Agenda  
Village of Arlington Heights  
Design Commission  
Community Room, 3rd Floor

**Item:** DC#18-025 - Arlington Downs Apartment Building - 3400 W. Euclid Ave.  
- Multi-Family

**Project Name:** Arlington Downs Apartment Building  
**Project Address:** 3400 W. Euclid Avenue  
**Prepared By:** Steve Hautzinger

**DC Number:** 18-025  
**Petitioner Name:** Chris George  
**Petitioner Address:** Arlington Devco  
350 W. Hubbard Street, Suite 640  
Chicago, IL 60654  
**Meeting Date:** May 8, 2018

1 EAST ELEVATION @ GARAGE - DC  
SCALE: 3/32" = 1'-0"

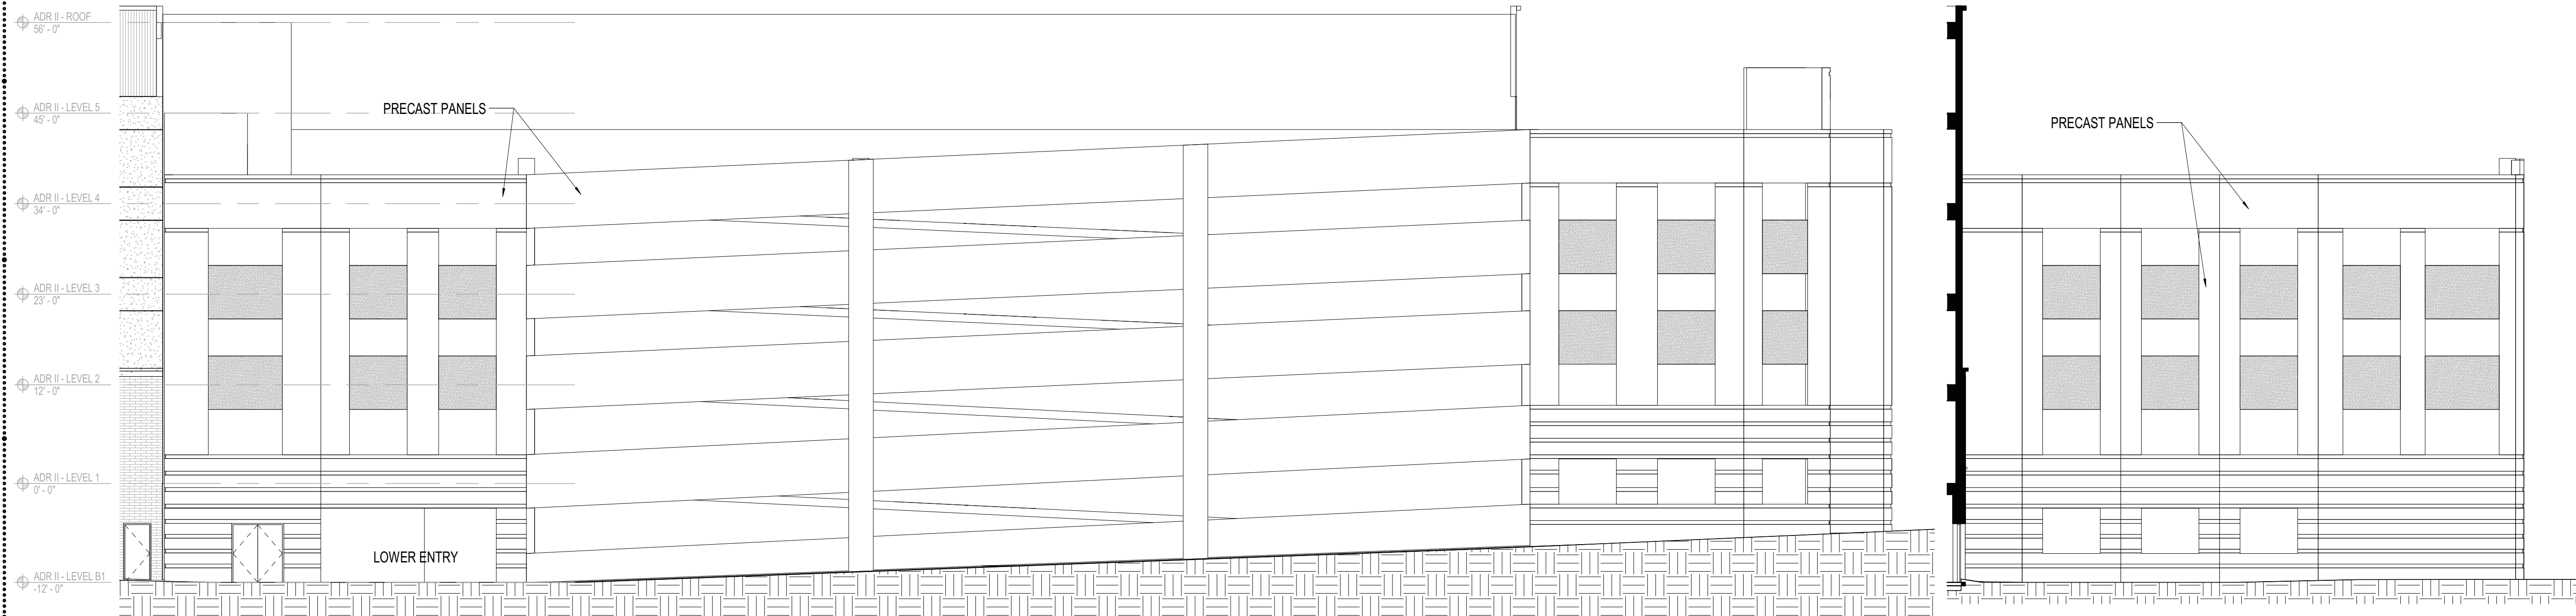
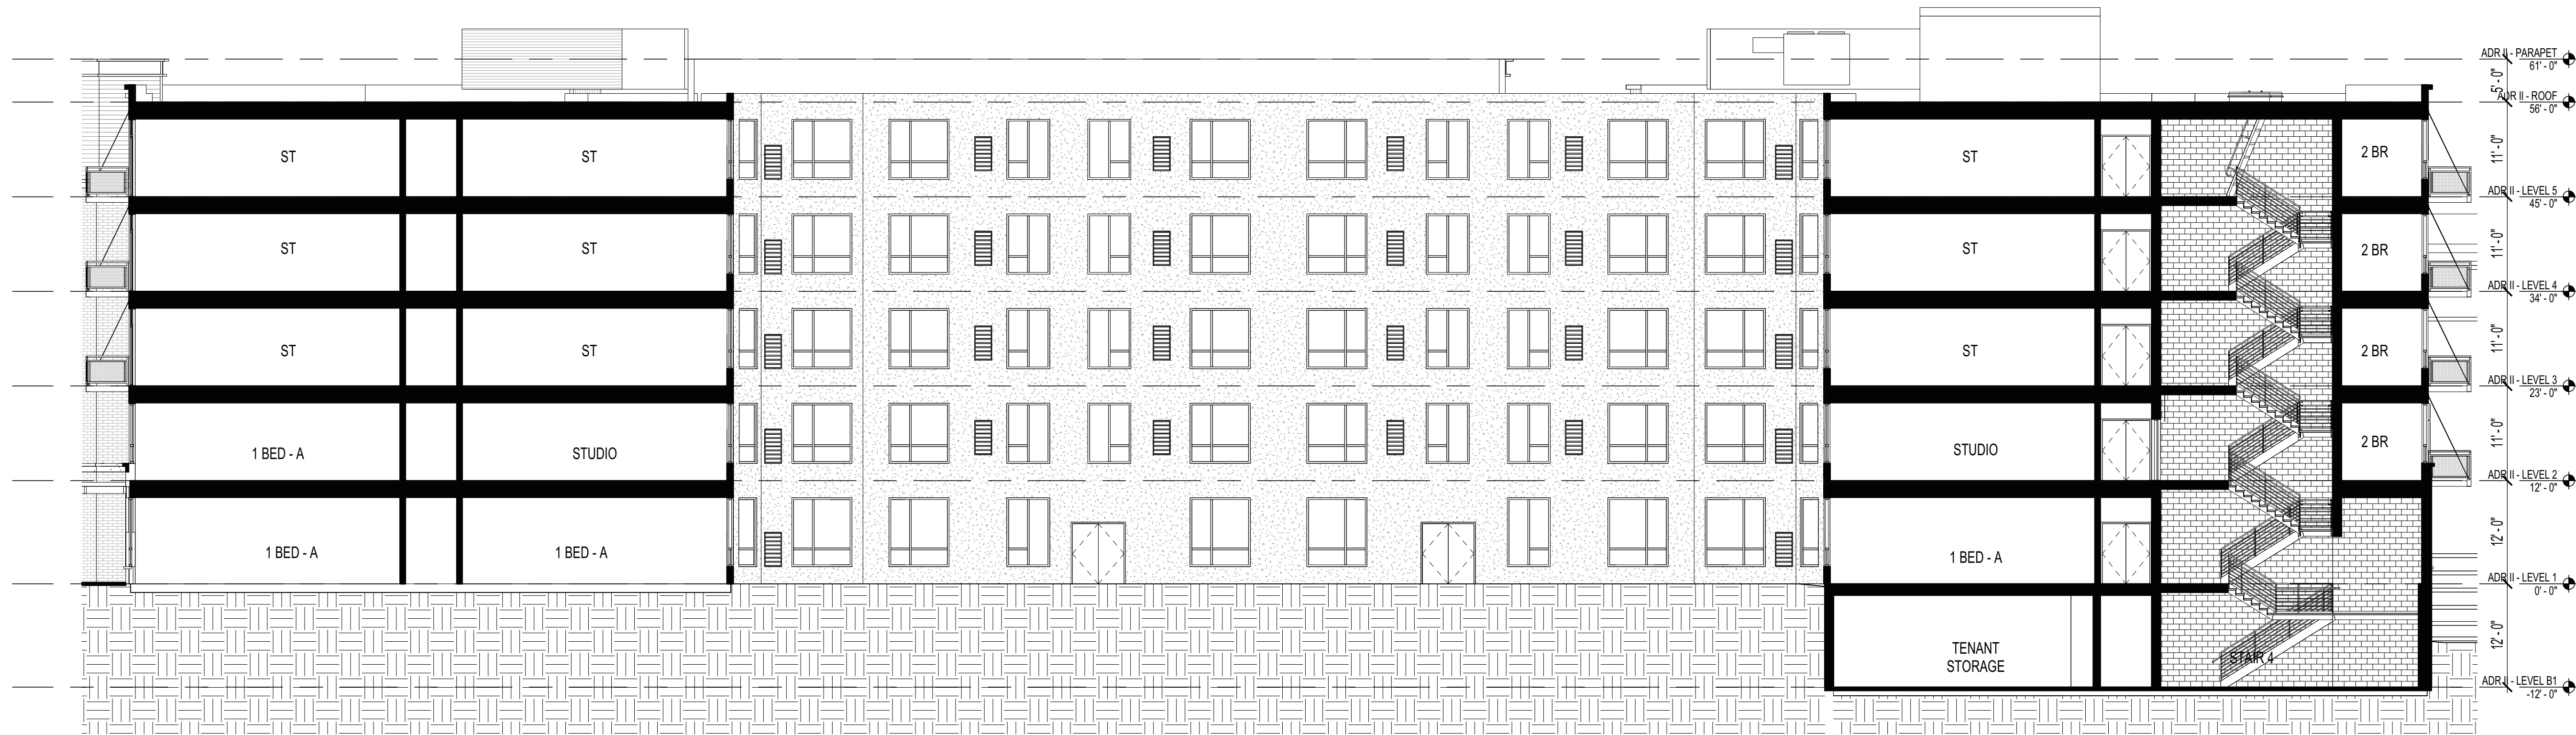
5. **VTAC Louvers.** The plans do not identify the finish of the VTAC wall louvers, but the petitioner has clarified that the louvers will be painted to match the adjacent wall surface. Staff agrees with this approach to downplay the appearance of the louvers.
6. **Parking Garage.** The parking garage will be visible from Euclid Avenue and from the adjacent roadways. It has nice detailing including reveals, recessed panels, and different sandblast textures, but it has a monochromatic appearance that does not complement the apartment building design.
  - a. It is recommended that additional color be added at the base and top of the garage to better complement the apartment building design.
  - b. Additionally, the center portion of the east wall should be enhanced with the same level of detailing as the north and south garage walls.

5. **VTAC Louvers.** All VTAC louvers shall be painted to match the adjacent wall surface.
6. **Parking Garage:**
  - a. It is recommended that additional color be added at the base and top of the garage to better complement the apartment building design.

- b. The center portion of the east wall should be enhanced with the same level of detailing as the north and south garage walls.
7. This review deals with architectural design only and should not be construed to be an approval of, or to have any other impact on, any other zoning and/or land use issues or decisions that stem from zoning, sign code or building or any other reviews. In addition to the normal technical review, permit drawings will be reviewed for consistency with the Design Commission and any other Commission or Board approval conditions. It is the architect/owner/builder's responsibility to comply with the Design Commission approval and ensure that building permit plans and sign permit plans comply with all zoning code, building code and sign code requirements.

**A310**

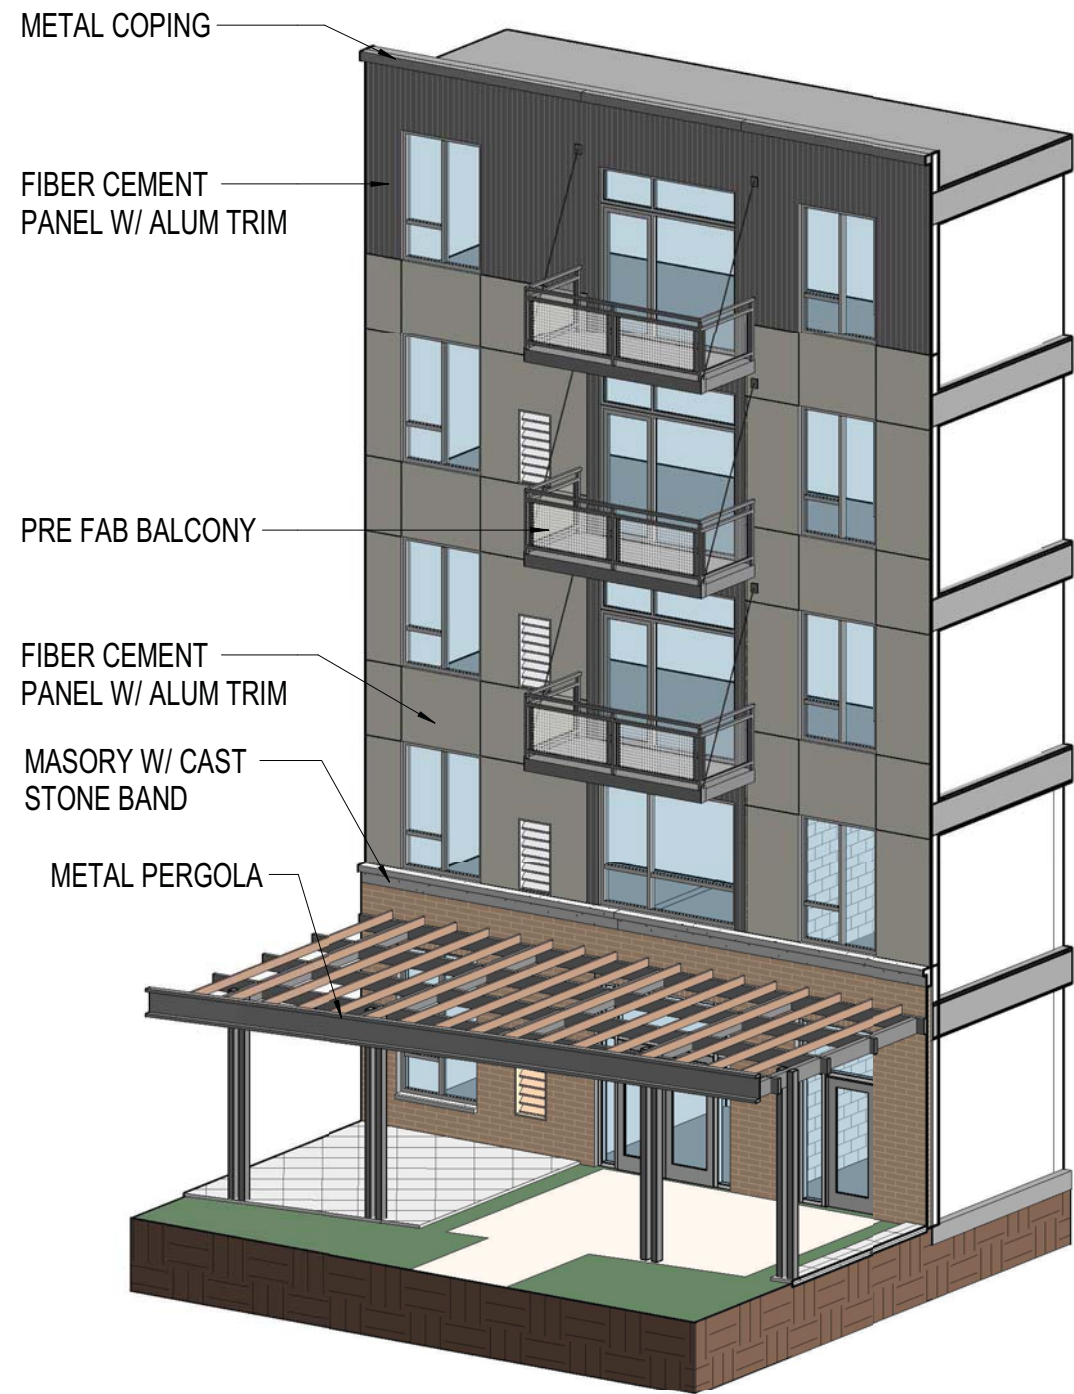
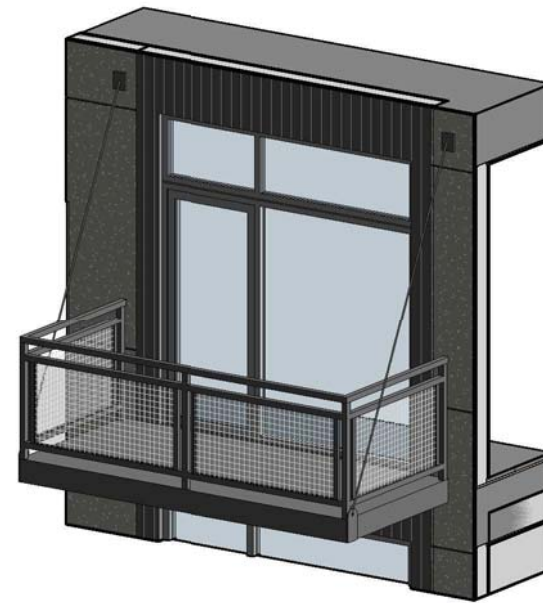
3. **Pergola.** The metal pergola feature on the west wall is a nice detail that follows the curve of the adjacent building and roadway. To enhance the design, consider angling the support columns to complement the existing entrance canopy at the adjacent "One Arlington" apartment tower.

3. **Pergola.** Consider angling the support columns to complement the existing entrance canopy at the adjacent "One Arlington" apartment tower.
4. **Entrance.** A wider and more unique canopy design is recommended to create a more prominent entrance feature. Consider a design to complement the entrance at the existing adjacent "One Arlington" apartment tower.

SECTION @ TYP BALCONY

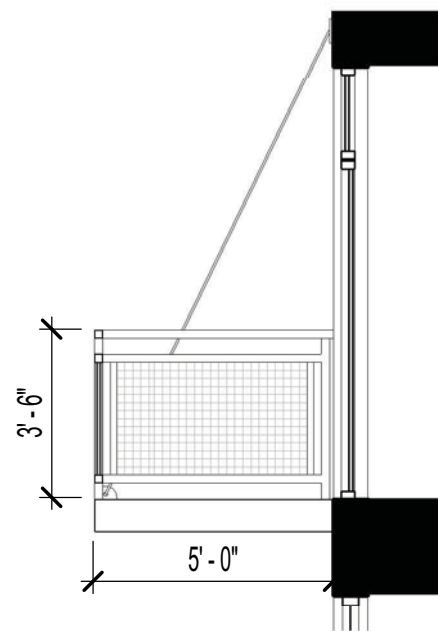
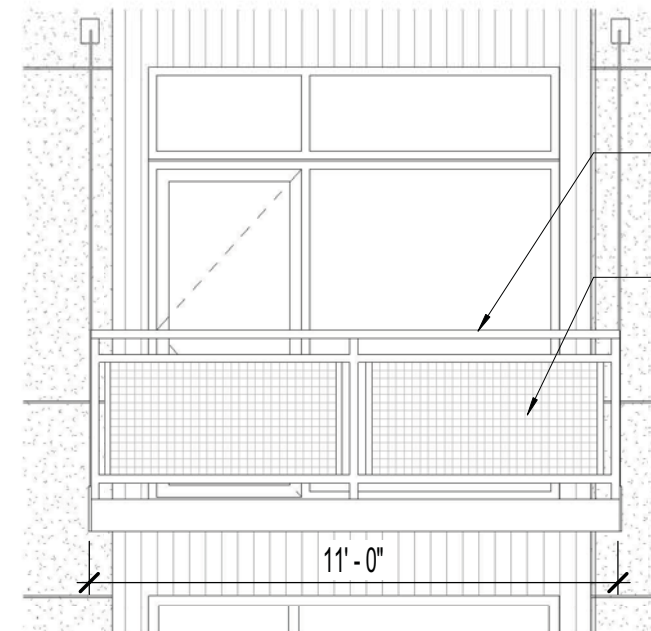
2. **Balconies.** The prefabricated metal balconies have a nice appearance that fits the character of the building. The balconies on the south wall are semi-recessed, which is a very nice detail to break up the large flat wall. It is recommended that the balconies on the other elevations be semi-recessed in this same way. At a minimum, the balconies on the west wall facing the roadway should be semi-recessed.

2. **Balconies.** It is recommended that the balconies on all sides of the building be semi-recessed to match the detail on the south wall. At a minimum, the balconies on the west wall facing the roadway should be semi-recessed.

ENTRY CANOPY

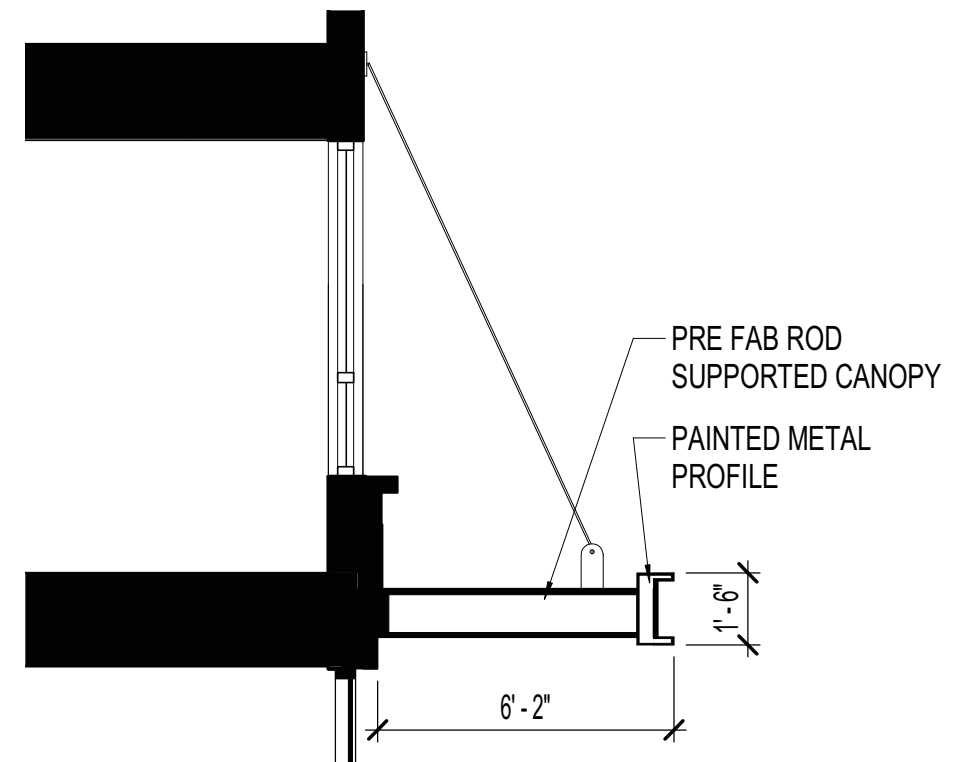
4. **Entrance.** The main building entrance is somewhat understated and lacks interest. A wider and more unique canopy design is recommended to create a more prominent entrance feature. Consider a design to complement the entrance at the existing adjacent "One Arlington" apartment tower.
